PRODUCT BULLETIN # 20696

Issue Date: 09-Jan-2015

TITLE: Change in inner box design.

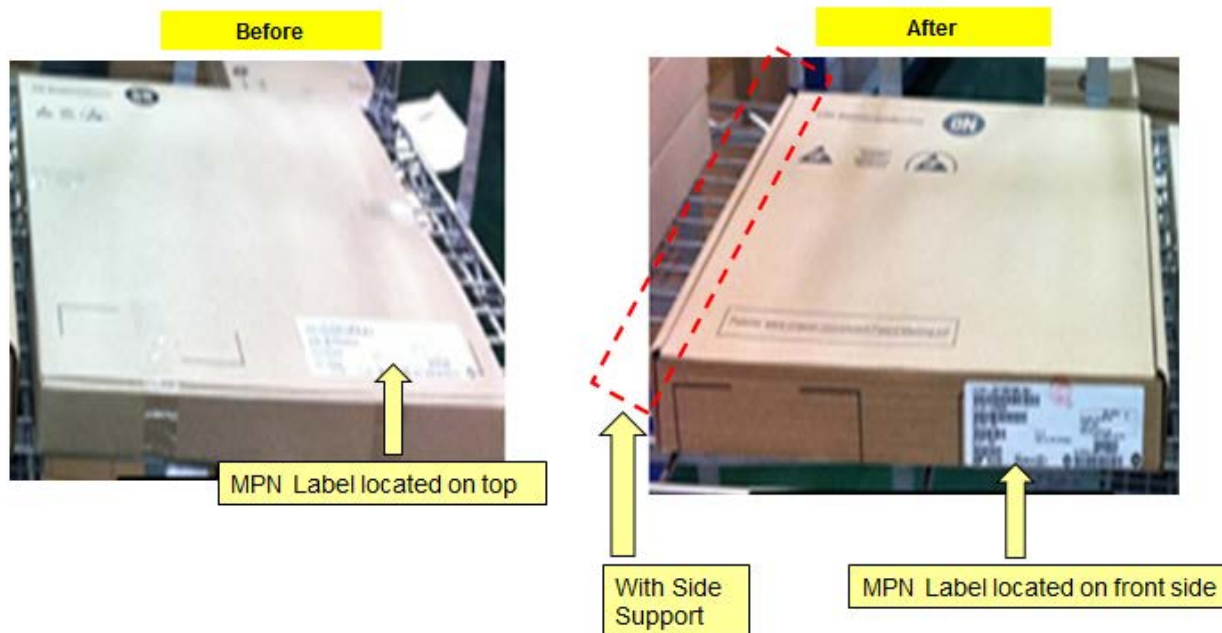
Change in Inner box design as part of the integration into the packing material of ON Semi spec.

Basic Dimensions Comparison

Current				Proposed
	BOX(TE-2412)		BOX(SMP)		ON Semi Pizza Box
	Measurement	Difference	Measurement	Difference	Measurement
Length	832 mm	25 mm	863 mm	56 mm	807 mm
Width	467 mm	107 mm	491 mm	83 mm	574 mm
Height	35 mm	13 mm	47 mm	1 mm	48 mm
Actual
